Mask Set Errata for Mask 3L87X

This mask set errata applies to the mask 3L87X for these products:

- MC68HC908QB8

Figure 1. Maximum Time for Other Execution

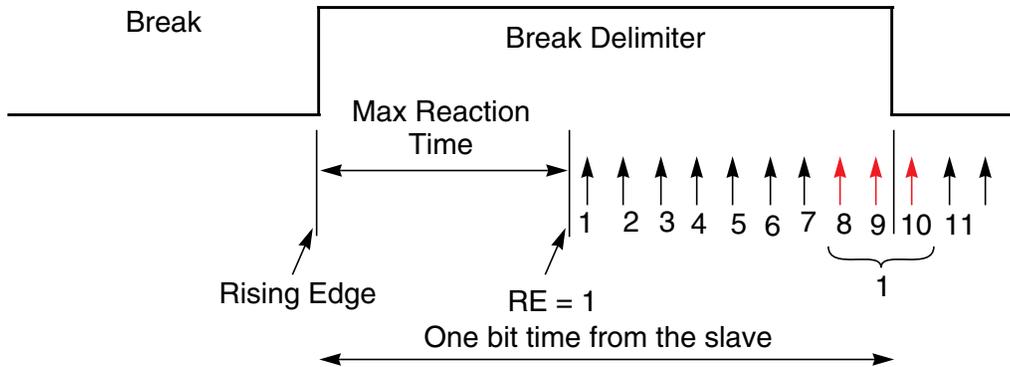
The time between when the rising edge actually appears on the receive pin and when the receiver is switched back on is finite and is governed by the timing of the falling edge of the delimiter. The receiver must be switched back on no later than 9/16th of a bit time before the end of the delimiter. See [Figure 1](#).

From [Figure 1](#), we also see that the “Maximum Reaction Time” is 7/16th slave bit-time.

The Maximum Reaction Time for this example system is $7/16 \times (44.5 \mu\text{s}) = 19.47 \mu\text{s}$.

From the instant the rising edge appears on the receive pin (detected via the arbiter AFIN bit or a timer interrupt), the software has to switch the receiver OFF and back ON within 19.47 μ s.

Because ground shift in the physical layer might also affect the timing of the falling edge of the START bit of the 0x55 synch byte (i.e., the end of the delimiter), best design practices suggest that the switching of the receiver should be done as quickly as possible after the rising edge is detected. The maximum reaction time calculated above should be treated as a guideline only.
